Seismic Walkdown Checklist (SWC)

Peach Bottom Atomic Power Station Unit 2
MPR-3815, Revision 3
Correspondence No. RS-12-173

Plan for Walkdown of Inaccessible Equipment and Assessment of Electrical Cabinet Internal Inspections

Equipment ID: OBV036

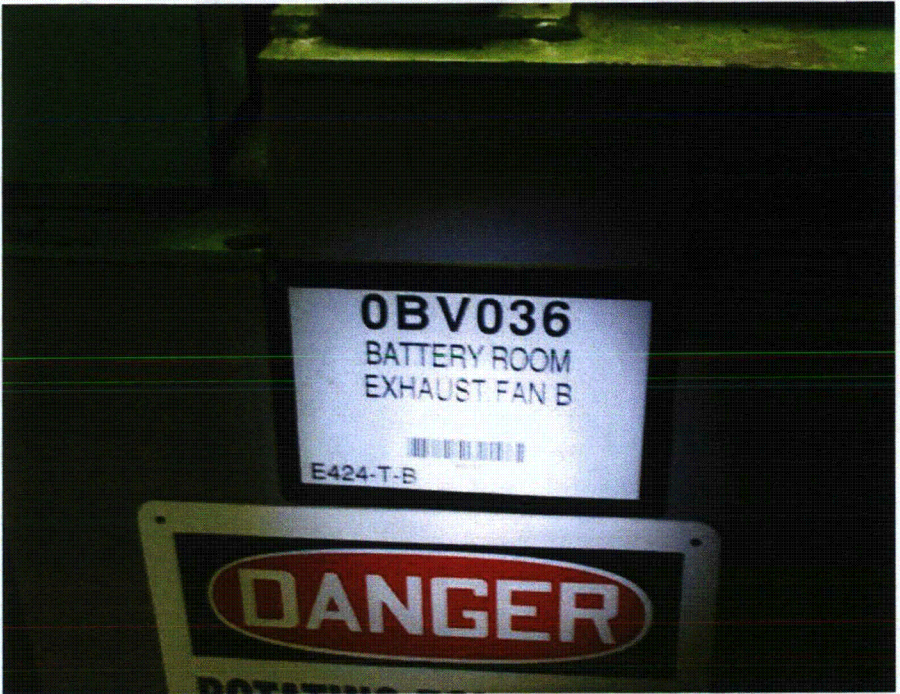
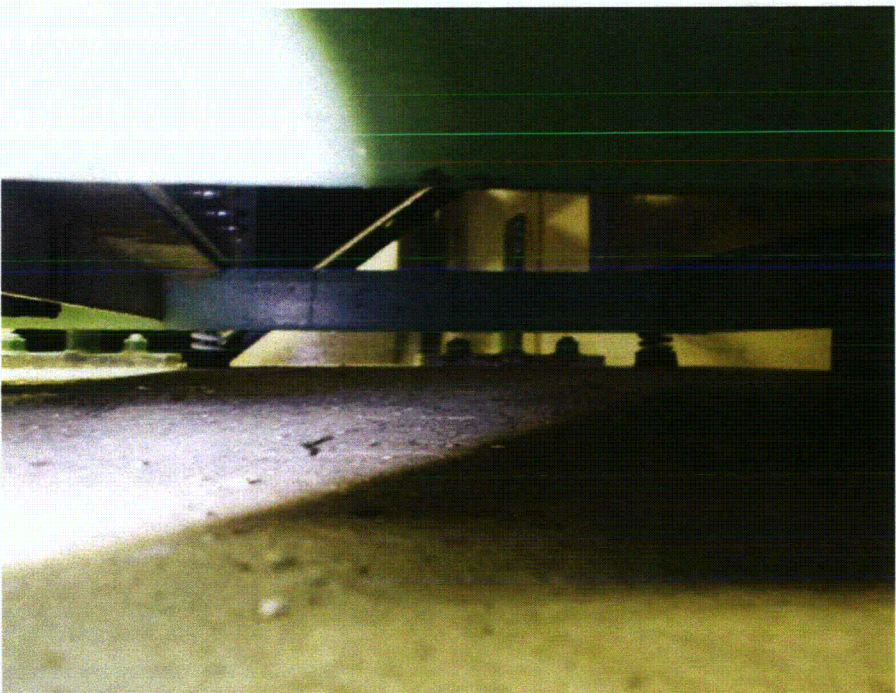
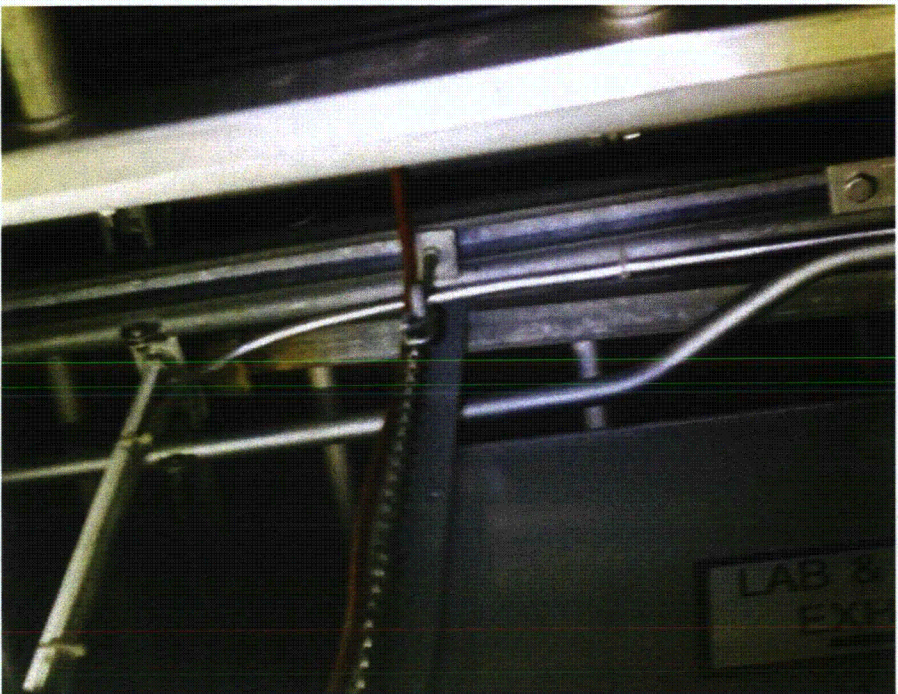
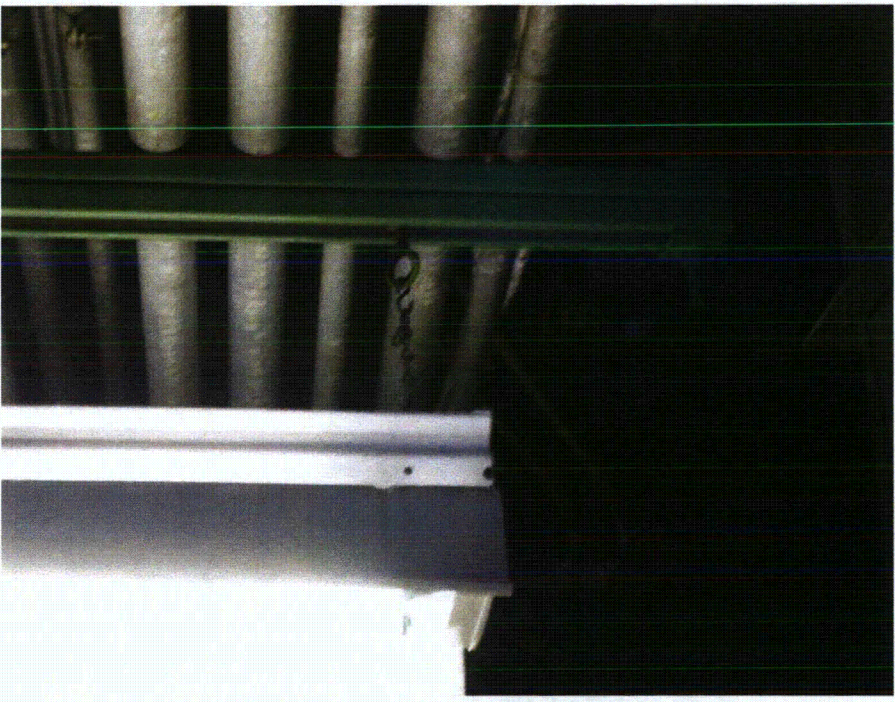
*Overhead fluorescent light fixture has open S hooks.
No soft targets in vicinity, so no issue.*
